Sent:Tuesday, October 22, 2019 12:13 PMTo:William Boyd; 'Benjamin Jacobson'Subject:Ridgeway Kizar SWD - Woodford

**To:** Rose-Coss, Dylan H, EMNRD **Subject:** [EXT] RE: Pooling Order & C-108

Cross Section Top of Devonian Formation Ben Jacobsen, Geologist **Kizer SWD #2** October 2019

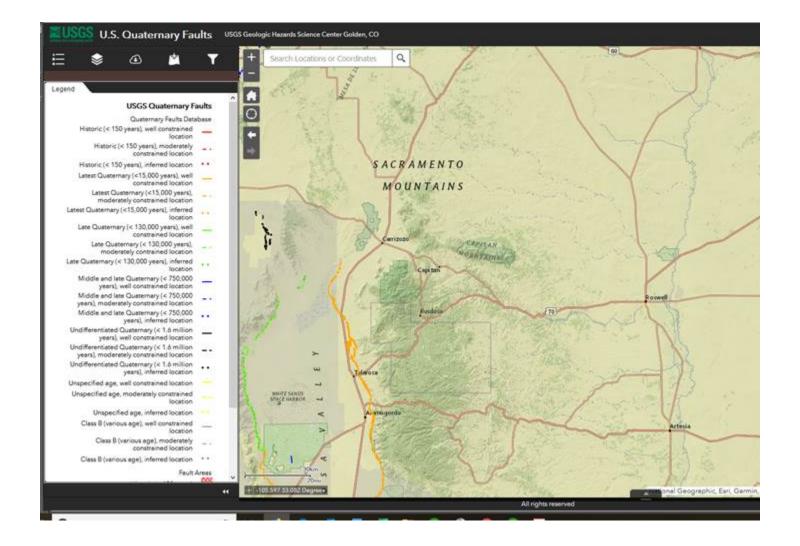
I screwed up and when I was using the "Schooner" SWD template for my write-up and caught every mention of Schooner except one. The mention of Schooner was associated with the Woodford faults, which was a bullet that I intended to delete. Attached is a "corrected/strikethrough" page and below is a screen shot showing that there are no Quaternary faults in the area per the referenced link in the footnote.

This corrected page should be satisfactory to OCD

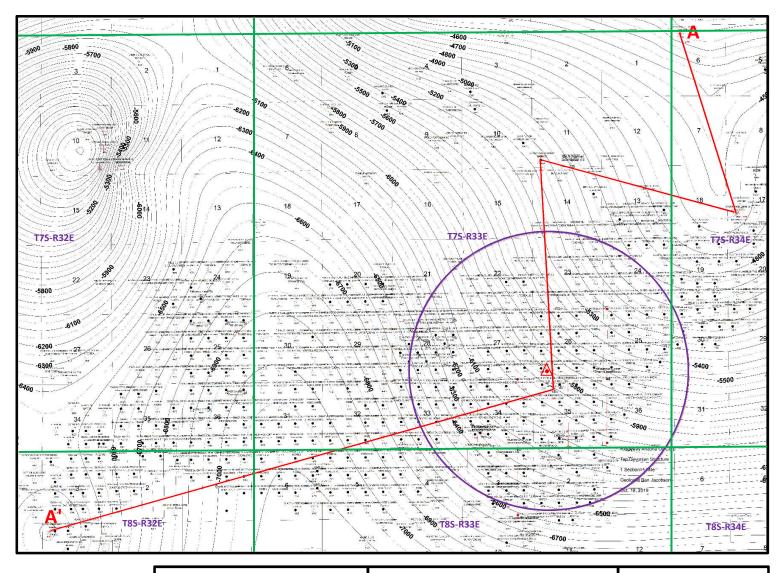
As analyzed by our geologist Ben Jacobson, I can provide the following response to your questions regarding lithology, deposition, and confining intervals, and supporting documentation attached:

Attached is the marked porosity log for the Old Hippie well, located 2035' FSL-2122' FWL-TWP: 6 S-Range: 34 E-Section 32; approximately 6 miles NW from the proposed Kizer SWD #2 location. It clearly contains proper modern logs to evaluate the AOI. The evidence shows the Devonian (300' gross thickness) is a dolomitic rock, containing as much as 6 percent porosity within the upper primary injection interval, and 6-14 percent in the lower interval above the Ellenburger. The Ellenburger (100' gross thickness), dolomitic rock, contains as much as 17 percent porosity. The Mississippian interval (100' gross thickness) limestone above the Devonian and Woodford, contains < 1 percent porosity. The Pennsylvanian (400' gross thickness) limestone above the Mississippian, contains 2-4 percent porosity with several massive layers containing less than 2 percent porosity. The Wolfcamp (400' gross thickness) limestone, contains 2-4 percent porosity within the lower 2/3rds, with several massive layers containing less than 2 percent porosity.
